HISTORIC LANDMARK COMMISSION  
STAFF REPORT

**Reuben Garage & Addition**  
PLNHLC2014-00364  
114 E. Hillside Avenue  
August 7, 2014

A request by Thomas White, architect, to build a detached garage and an upper level addition to a noncontributing structure located at 114 E. Hillside Avenue and in the Capitol Hill Historic District. The subject property is located in the RMF-35 (Moderate Density Multifamily Residential) zoning district

A1 Site Plan  
1"=10'-0"

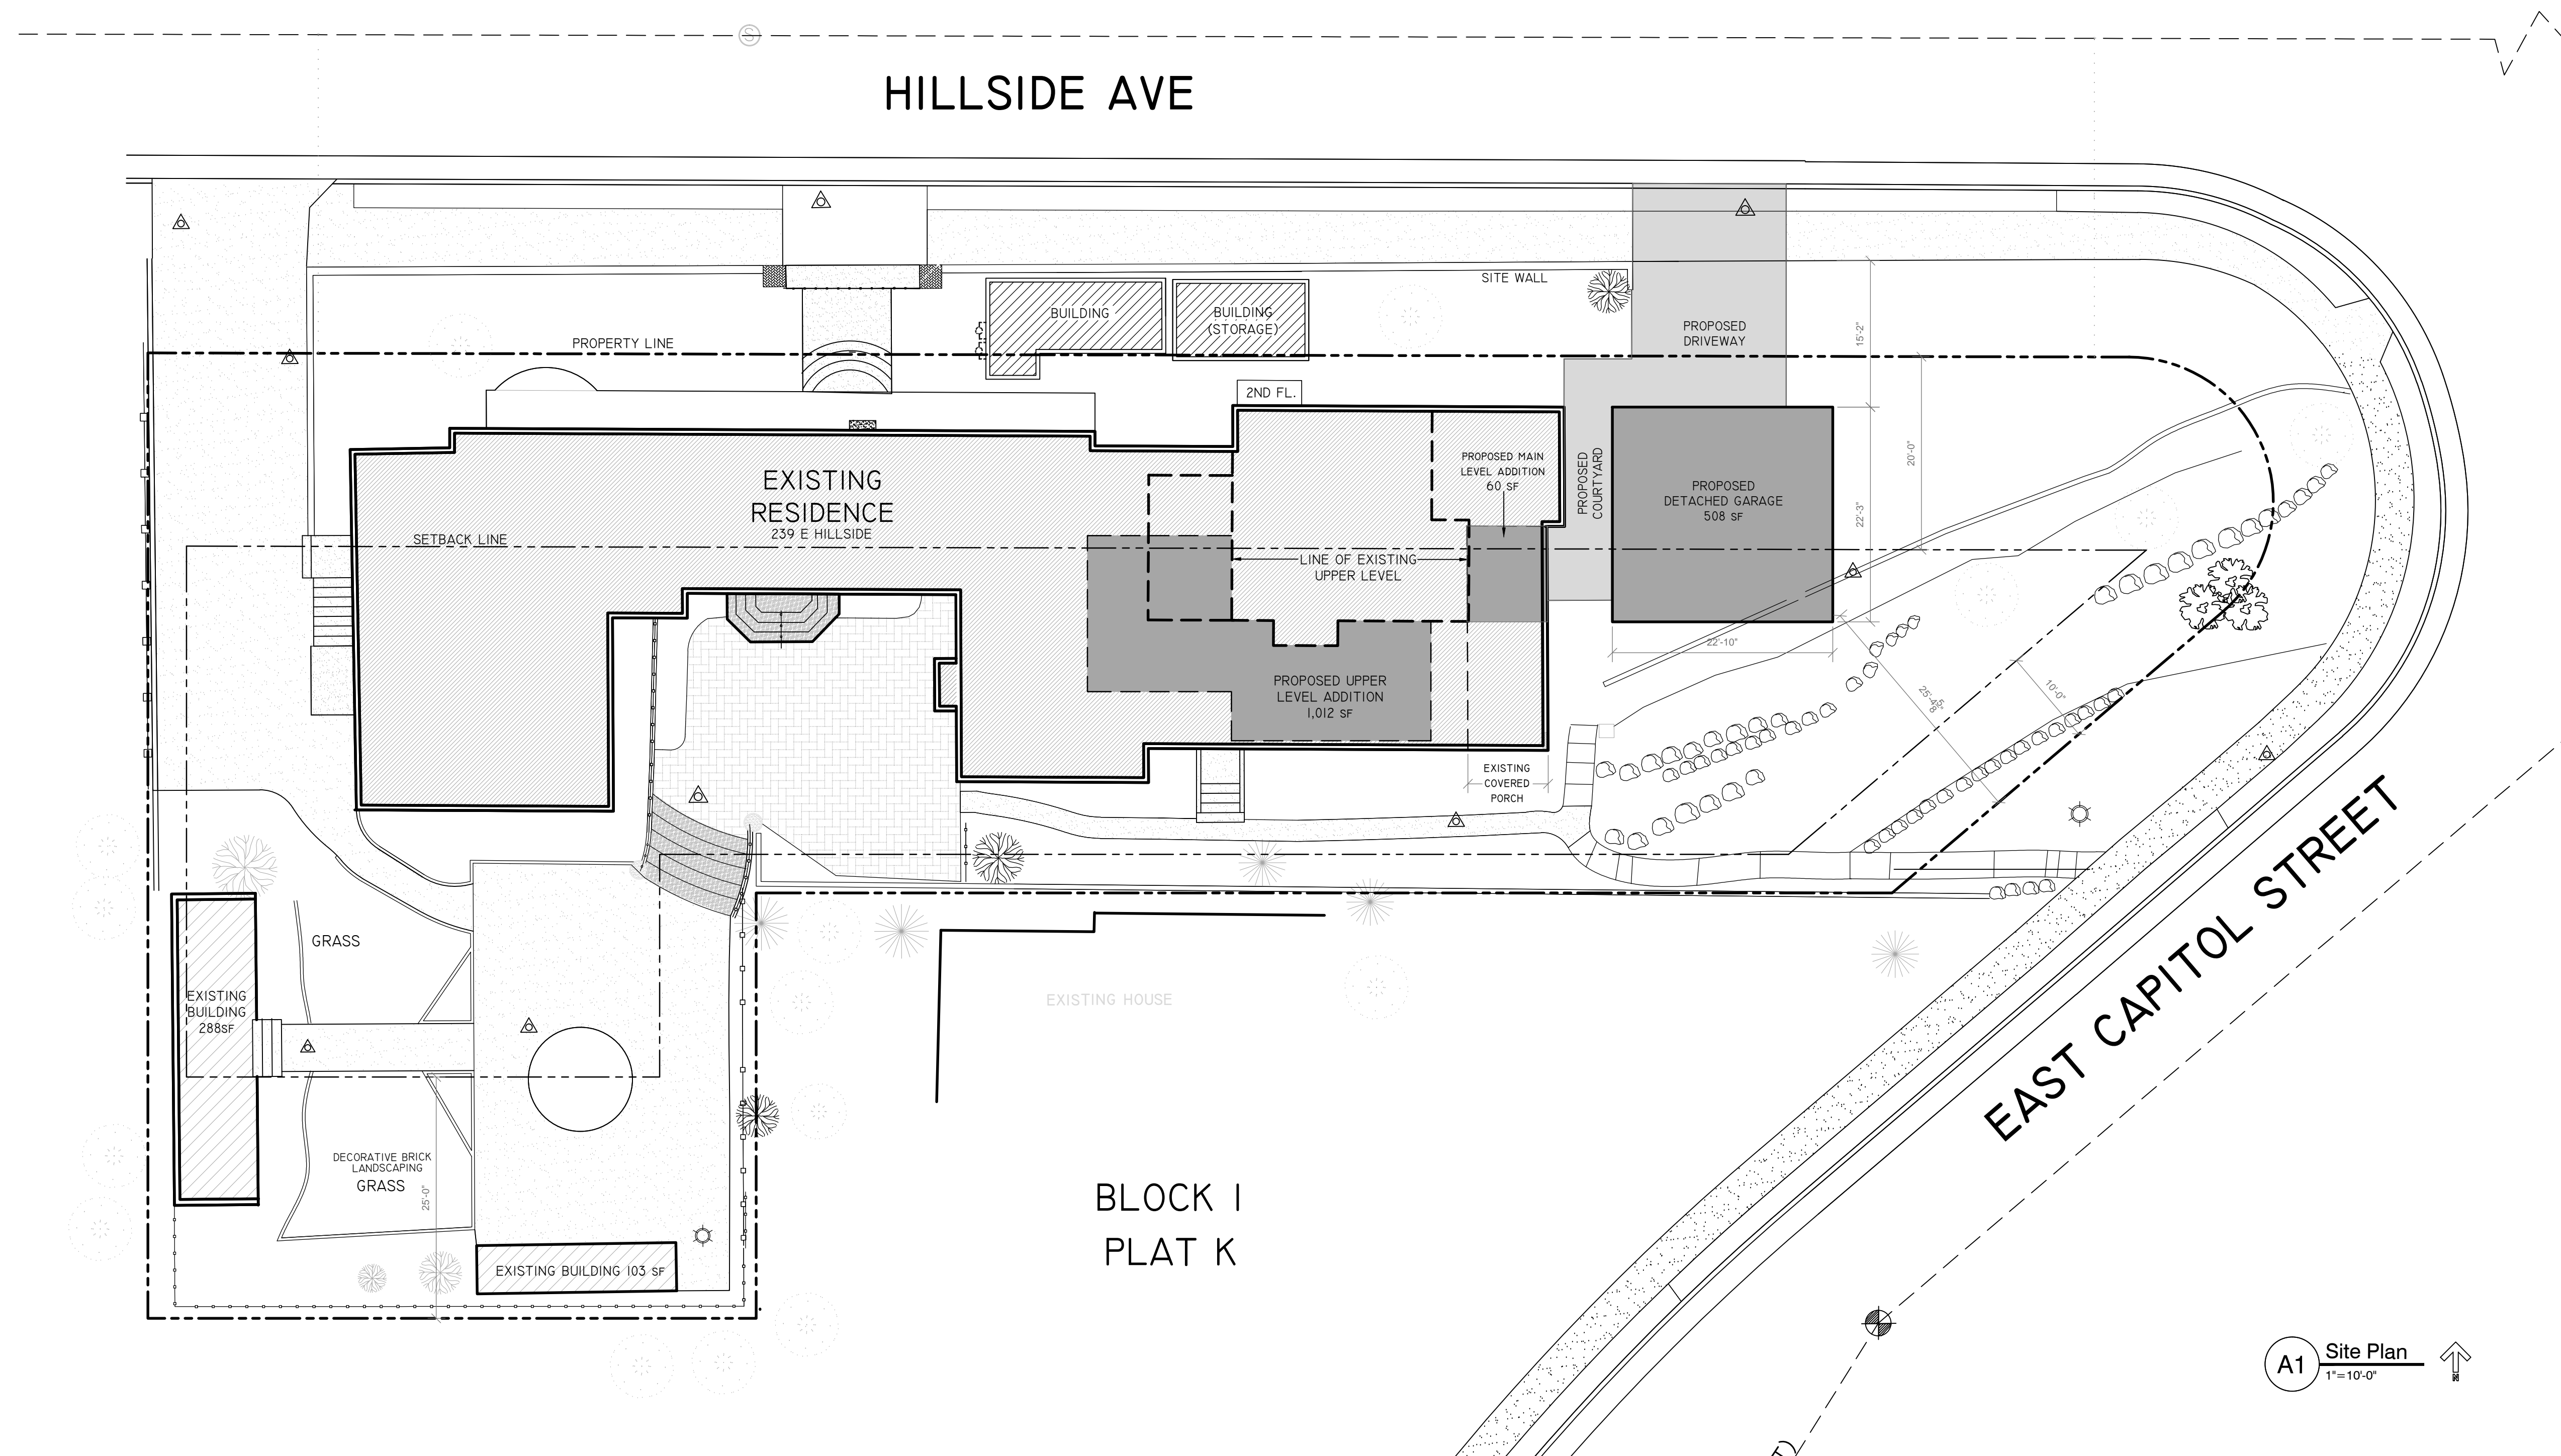
Also, the distance from the public sidewalk to the front façade of the proposed garage is 15'-2". The Transportation Division's requires a setback of a minimum 17'-6". However, the Transportation Division will approve the garage at the proposed setback if a "No Parking" sign be placed on the front of the garage door to restrict parking and staging on the public sidewalk.

The 15'-2" setback from the public sidewalk to the face of the new garage requires posting "No Parking" signs on the front of the garage door to restrict parking and staging on the public sidewalk, minimum setback is 17'-6" from back of walk. Maintain the required 10'x10' clear sight zone on each side of the driveways.

1. That a "No Parking" sign be placed on the front of the garage door to restrict parking and staging on the public sidewalk.

Location of the Proposed Garage

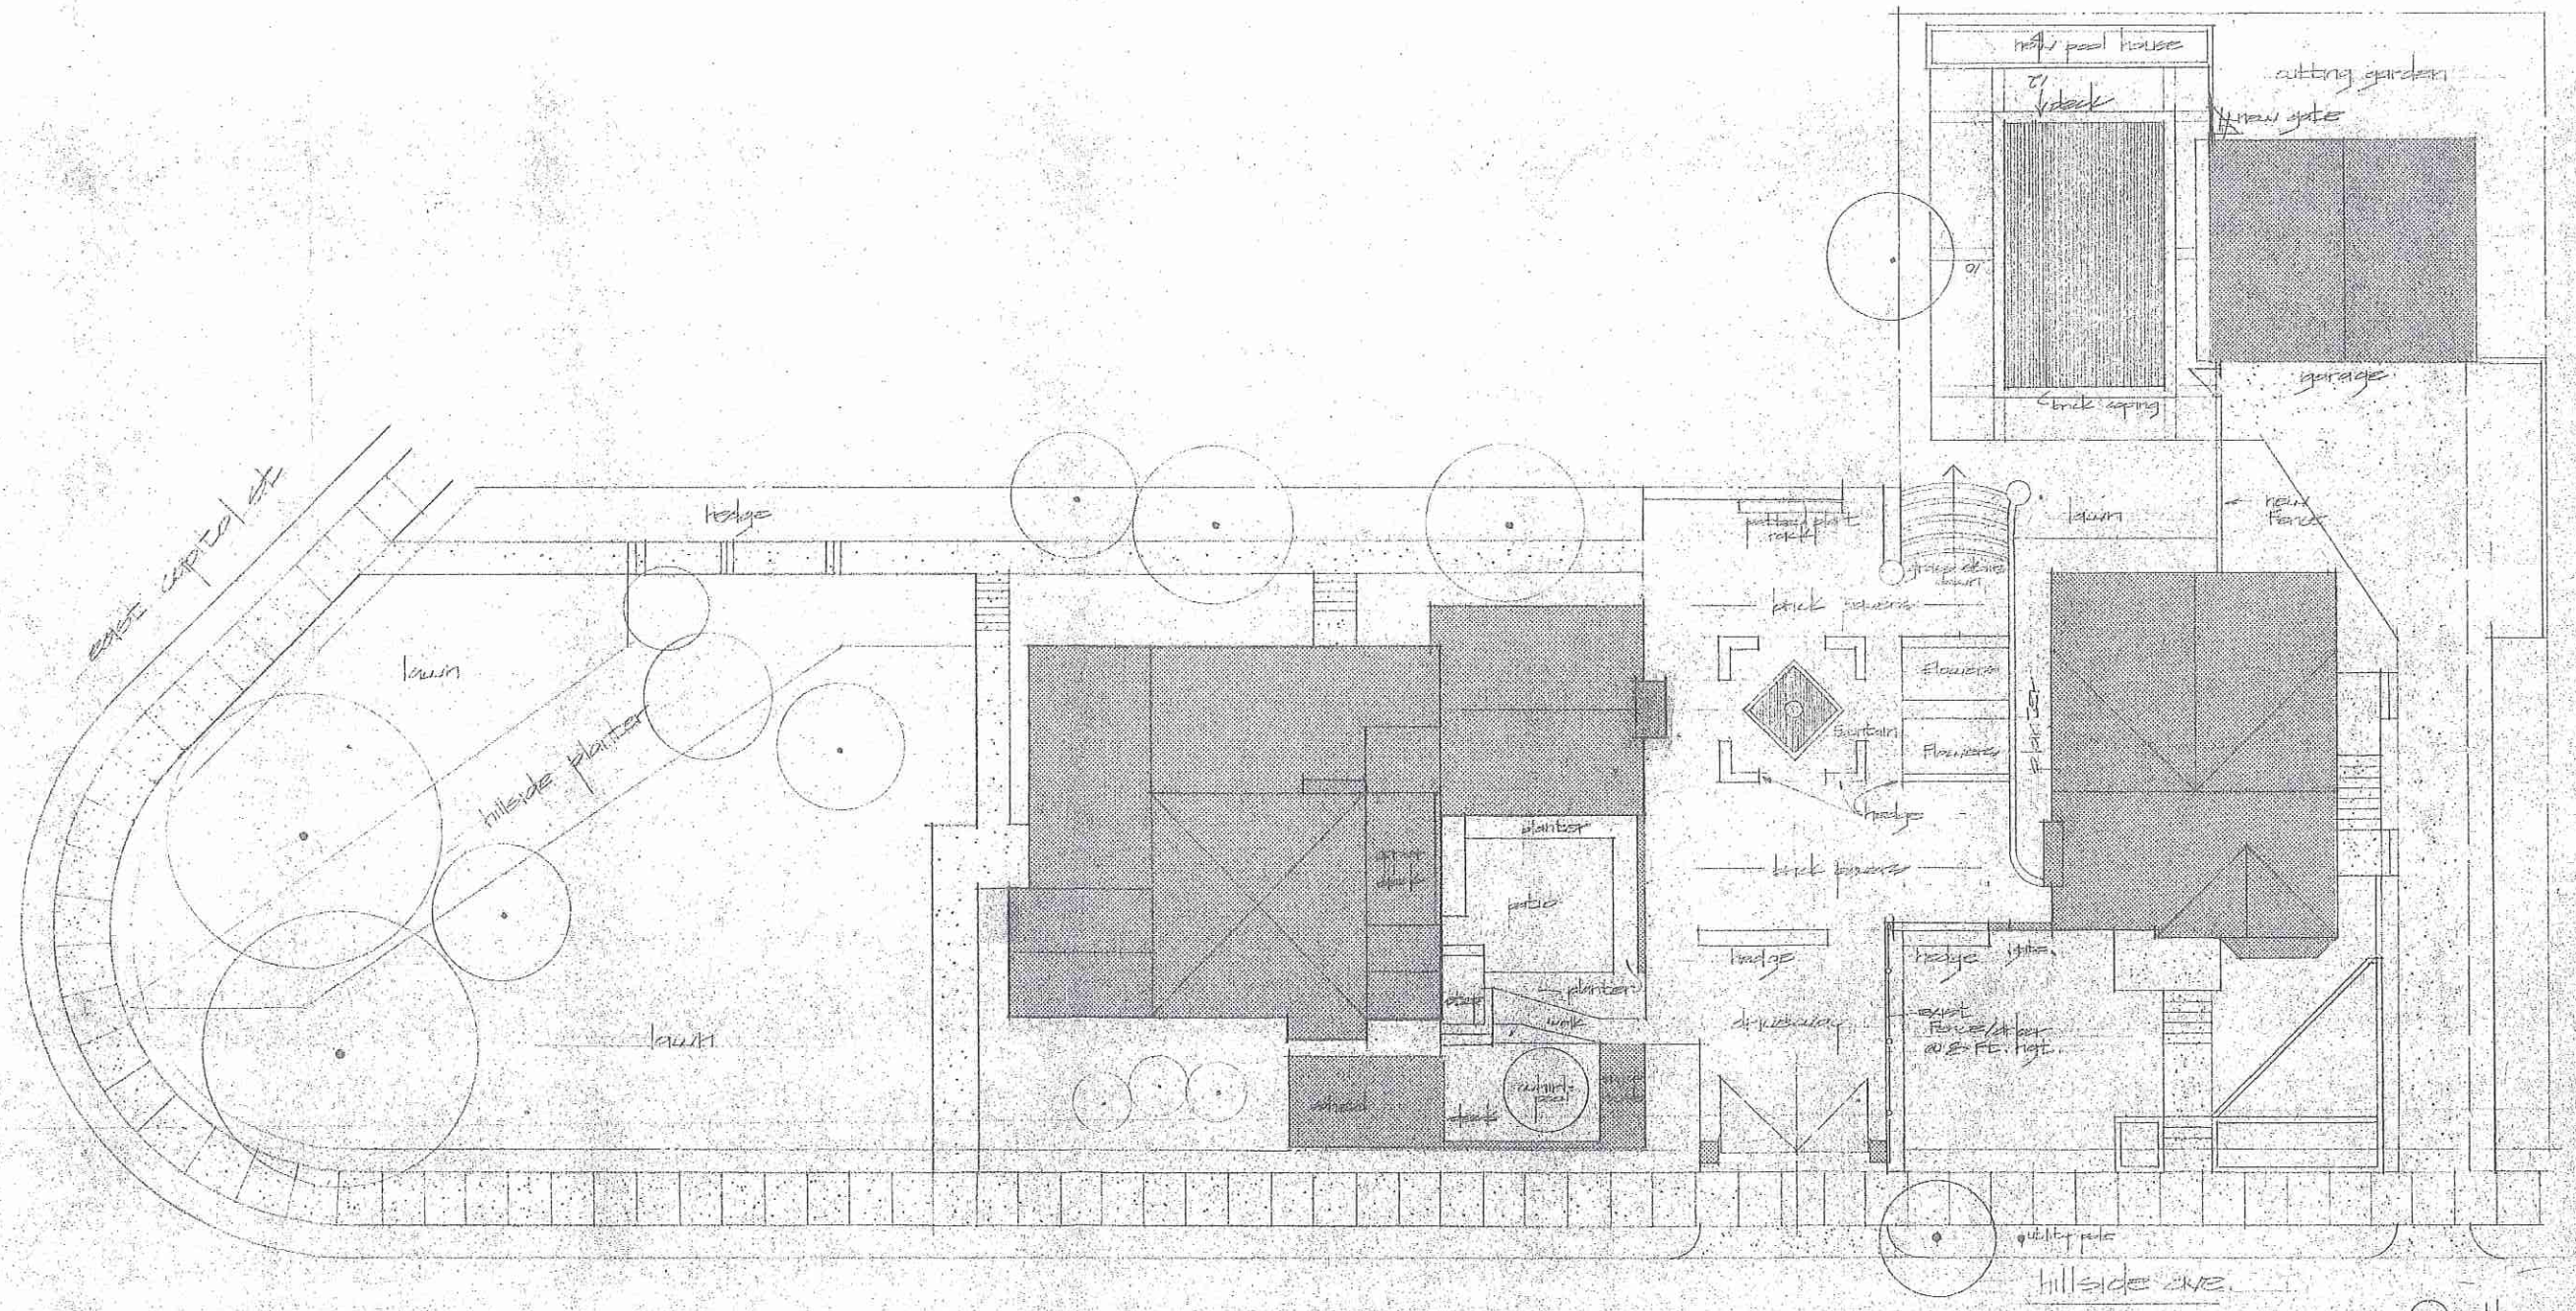
The proposed garage will be detached and located 4 feet from the principal structure. It will be aligned with the front façade of the house. The proposed garage will cover portion of the east façade of the house which is visible from the street, but on the south elevation, or front façade, the proposed garage matches the existing home with an arched garage door that matches other arched elements of the house. The existing principal structure has decorative reliefs with precast concrete column details. The proposed garage will copy the decorative details and columns. The roof of the proposed garage will also be as a continuation of the existing roof, with the same materials and same roof pitch.
